**Veterans
Administration**

SUBJ: Addendum to Amendment #37 to NRC Biproduct Material License #04-01935-03.

Control No. 70233 - (MS 15)

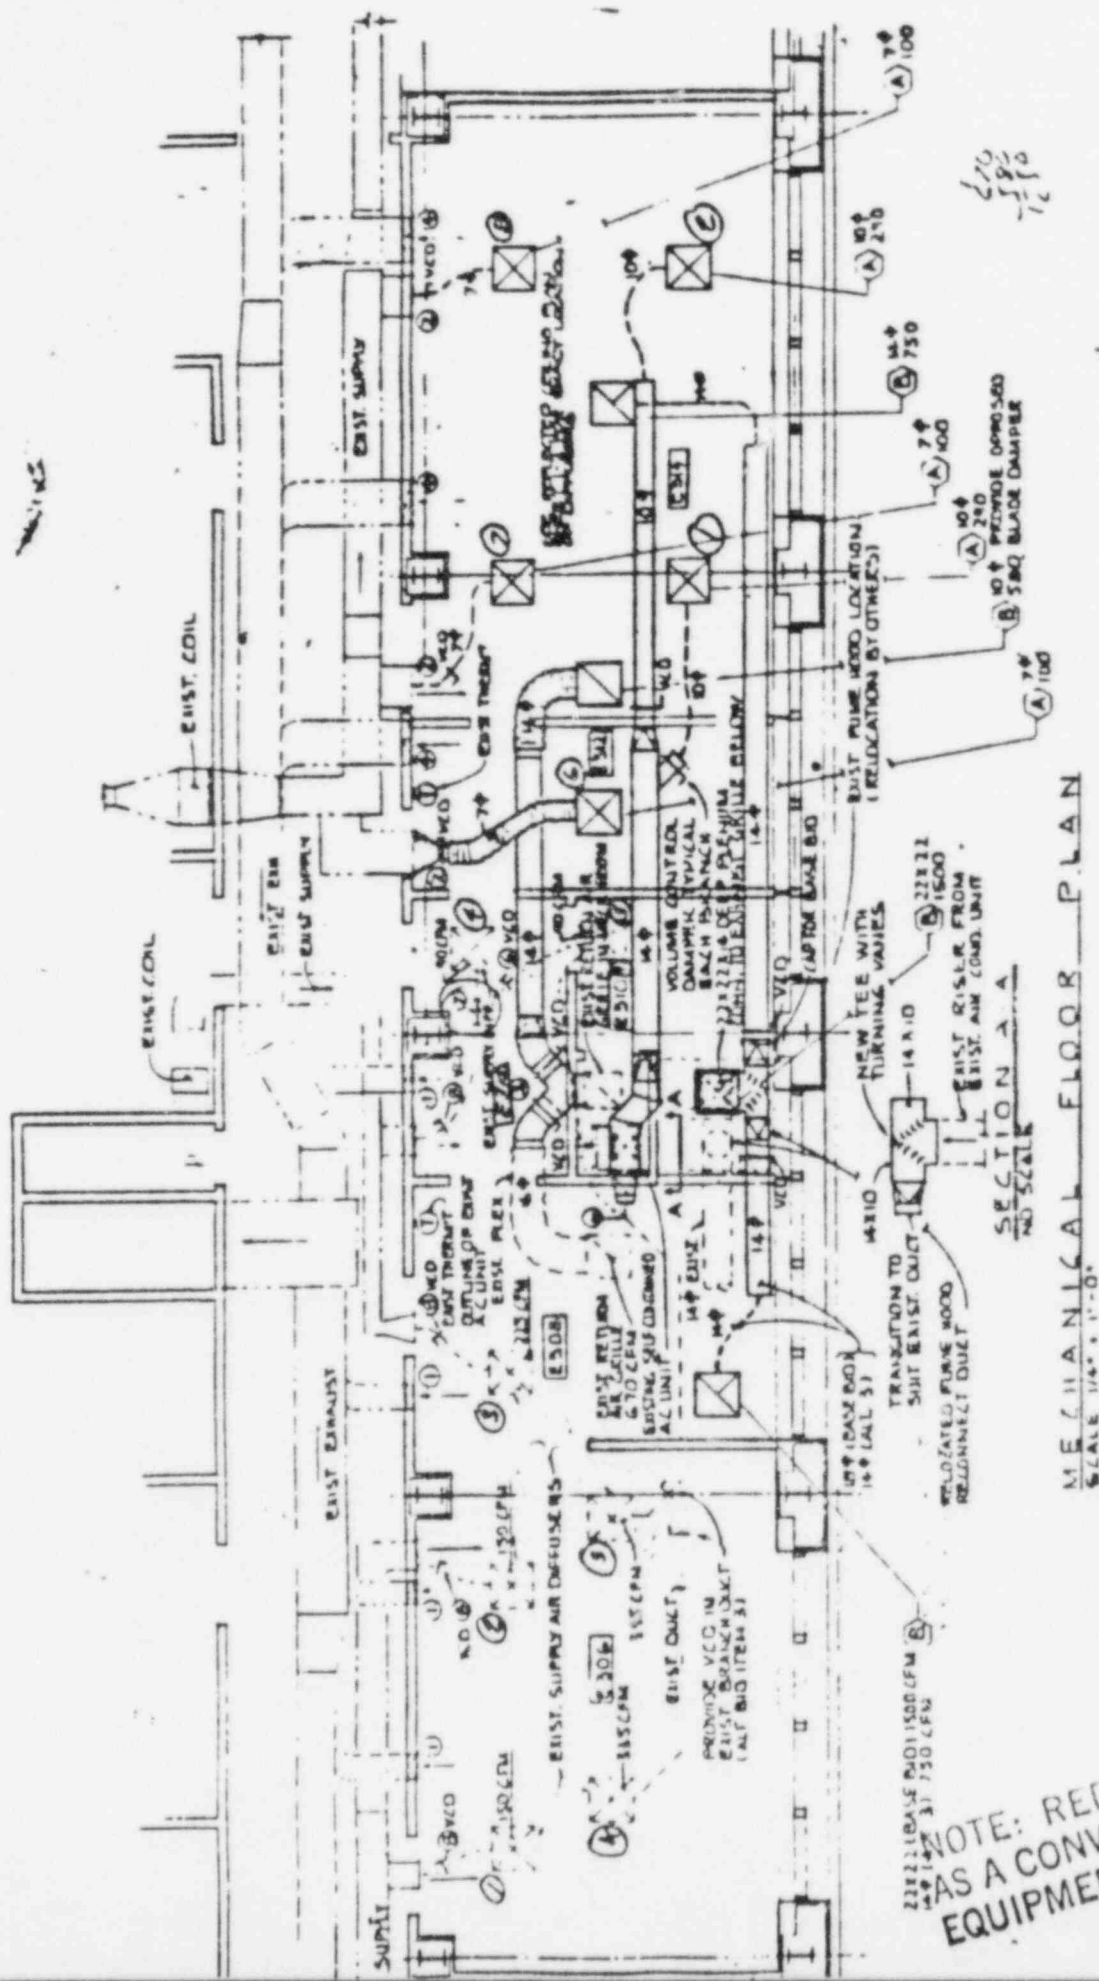
• It is not clear where the exhaust + return air vents move the air.

• What areas are described? What are the areas used for? Rooms E306, E308, E310, ~~E312~~ E312, and E314 are shown on the diagram. Uses as noted below:

- Why did you refer to the August 15, 1983 submittal?
They are using the same number of patients, the same doses, and the same number of views per patient.
- Mr. Holmes will submit further information on air flow. He will show the calculations which verify that the unrestricted ~~area~~ area air concentration limits are met within the nuclear medicine area.

This letter is an addendum to the request for amendment #37 on July 17, 1985, Item No. 5: The differential ventilation rate is -820 cfm (not -380 cfm). This -820 cfm value is found by (1) identifying the supply vents A, B, E, H, K, M, N (see identification sheet and map - attached, obtained from VA Engineering Service), (2) measuring their linear flow rates, (3) calculating the volume flow rates by multiplying the linear flow rates by the respective vent area (see previously submitted Vent Air Flow Rates), (4) summing the supply vent volume flow rate values and (5) subtracting the full open hood volume flow rate from that sum. This results in the differential ventilation rate of $80 + 100 + 220 + 90 + 105 + 100 + 90 = 1605$ equals -820 cfm. This improved ventilation rate differs from the -380 cfm value quoted in the letter of 7/17/85 because vents C and D were mistaken as supply vents while they are vents for internally recirculated (cooled) air. CONCLUSION: Negative air pressure occurs within the Nuclear Medicine facility due to the negative air ventilation rate produced by the hood at full open position.

Mr. Holmes stated that there is a self-contained air conditioner for the nuclear medicine facility. He will submit more information describing the air flow.
